# SAN FRANCISCO PLANNING DEPARTMENT

## Memo to the Planning Commission

*Date:* December 3, 2015  
*Case No.:* **2014.1079D, DRP, -02, -03/ 2014.1080D**  
*Project Address:* **1783 Noe Street**  
*Zoning:* RH-1 (Residential House, One-Family)  
40-X Height and Bulk District  
*Block/Lot:* 6652/016A  
*Project Sponsor:* Geoff Gibson, WinderGibson Architects  
351 9<sup>th</sup> Street, Ste. 301  
San Francisco, CA 94103  
*Staff Contact:* Tina Chang – (415) 575-9197  
[tina.chang@sfgov.org](mailto:tina.chang@sfgov.org)  
*Recommendation:* **Do Not Take DR and Approve Project with Modifications as Proposed**

PROJECT : 1783 Noe Street

**1783 NOE\_ REVISED BUILDING ENVELOPE 10' SETBACK**  
11.18.2015

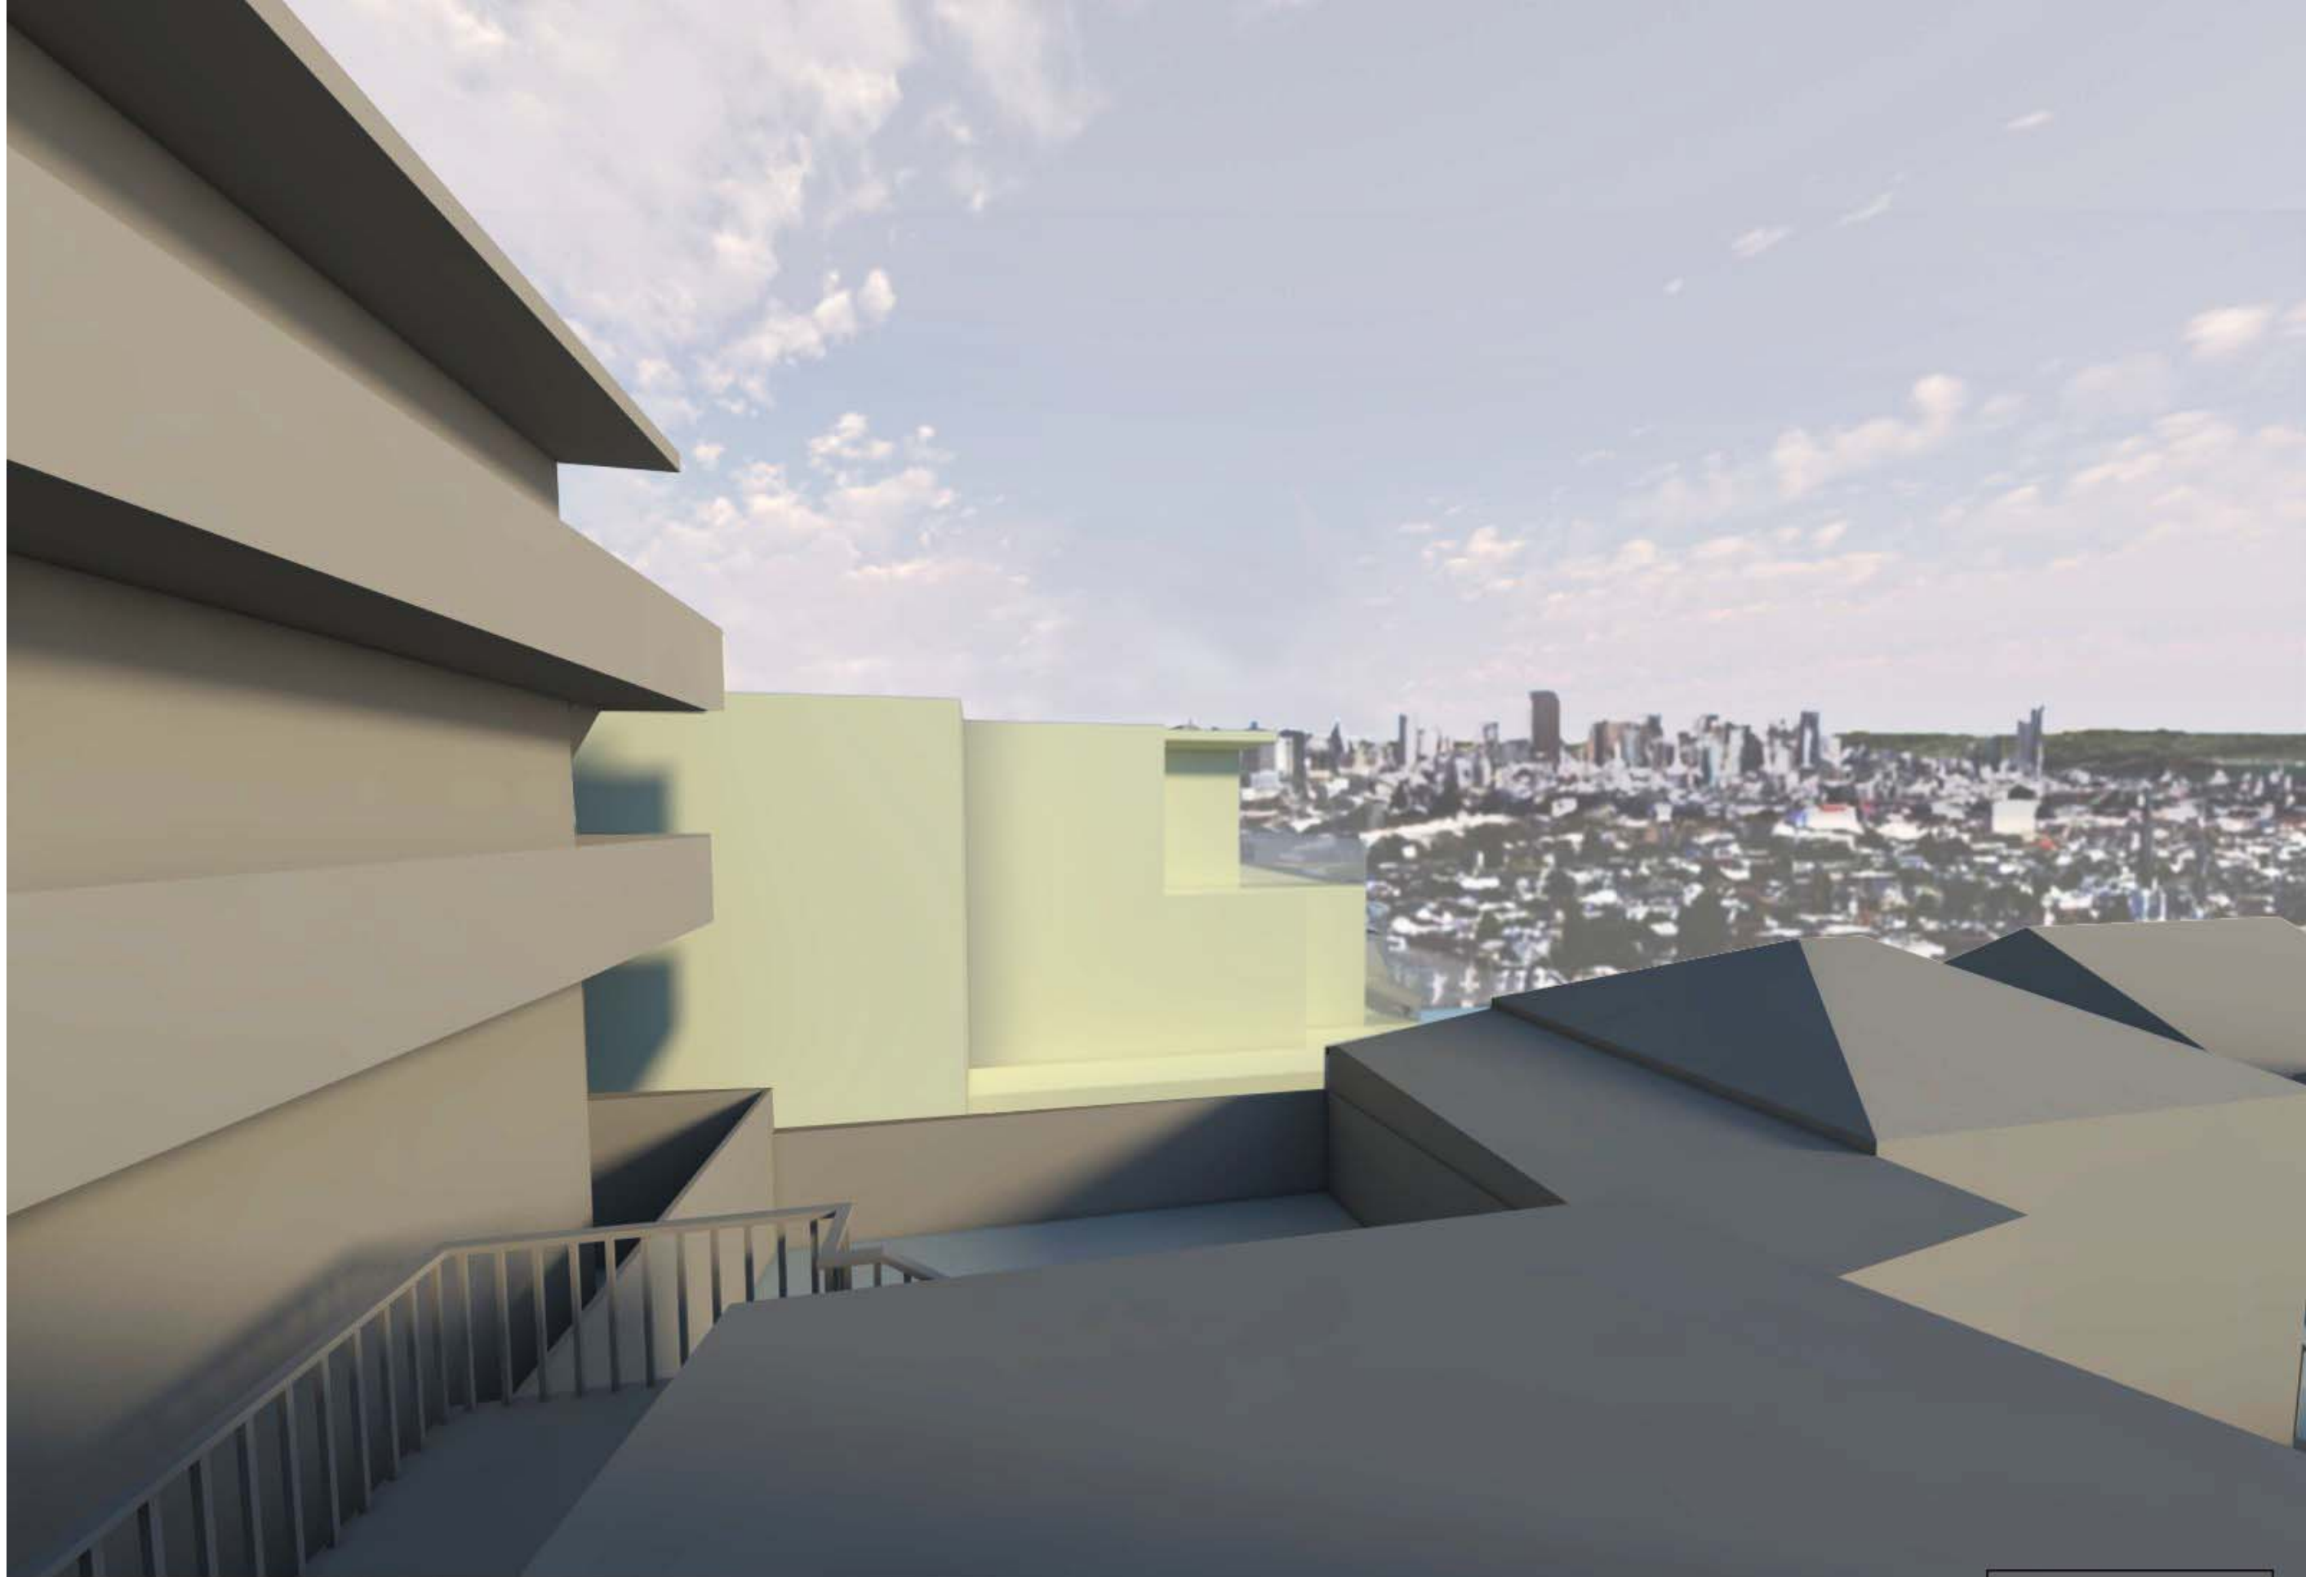
**View from Harrington property:** We have produced a series of renderings from the point of view of the rear windows at DR Filer Harrington's property at 105 Laidley Street. These views include the original 311 notification design as well as the massing of the revised design. For the revised design, we have shown this view with 5', 7' and 10' side setbacks at the Second and Third Floors. As explained above, the only dimension remaining undecided is this side setback. These renderings demonstrate that the change in perception of the building from Harrington's viewpoint between the 5', 7' and 10' setbacks is nominal. I would like to note that the Planning Code requires no side setback and the RDT requested only a 3' side setback. A setback of even 5' is unusual. A setback of 7' or 10' is unprecedented and punitive.
